BOONE COUNTY, MISSOURI

Request for Bid #: 27-19MAY16 – Chain Link Fence Installation

ADDENDUM #1 - Issued April 26, 2016

ECC STORAGE

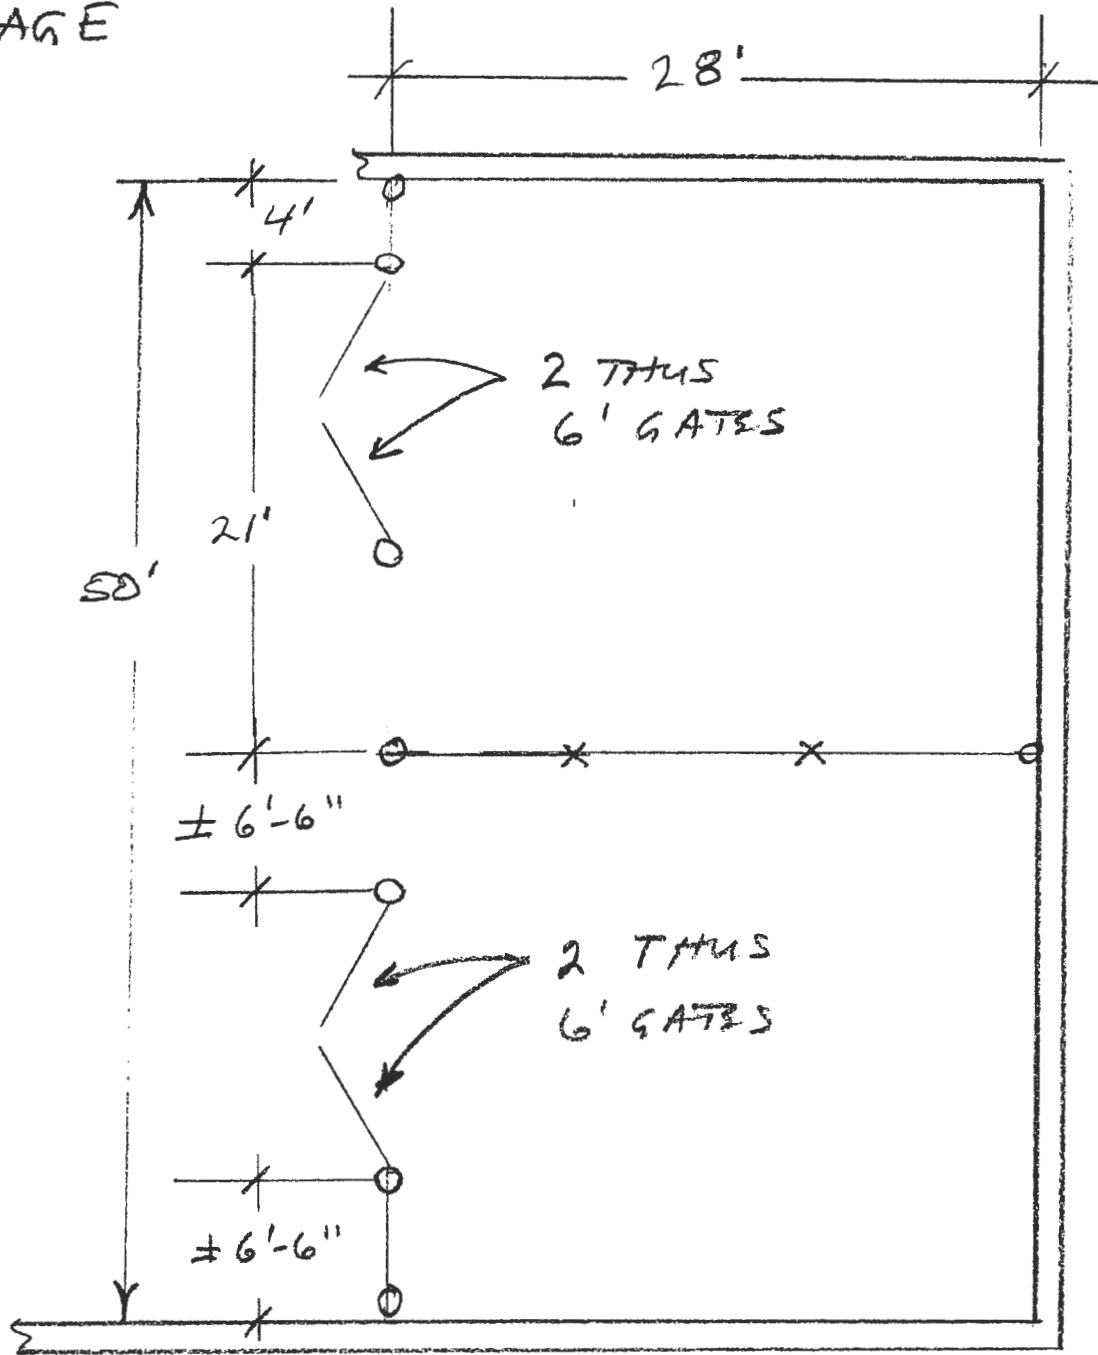
3. CHANGE wording in Section 2.2.3 from "EEC Storage area" to "ECC Storage area".
4. REPLACE Section 2.2.3.1. with the following language: Fencing under this section will be installed in the unfinished lower level of the new ECC building. Building construction style in this area consists of poured concrete walls, floor and ceiling. Posts shall be securely attached using floor flanges with wedge style concrete anchors and supported with wall or ceiling clamps to prevent fence movement and support gate operation. Gate support posts must be securely attached to support gate swing operation. Work will include approximately 78 lineal feet of fence construction. There is vehicle drive access very near to this work area.

5. ADD Section 2.2.3.2. Fencing shall be nominal 8' height with top rail and bottom wire. No barbed wire will be used. Vendor to furnish gates at specified locations as shown on Attachment D. Each gate pair shall have one rod or pin to anchor into concrete floor and a gate latch that can be secured with a padlock. The floor area below gates must remain clear of plates or attachments to permit the use of pallet jacks.
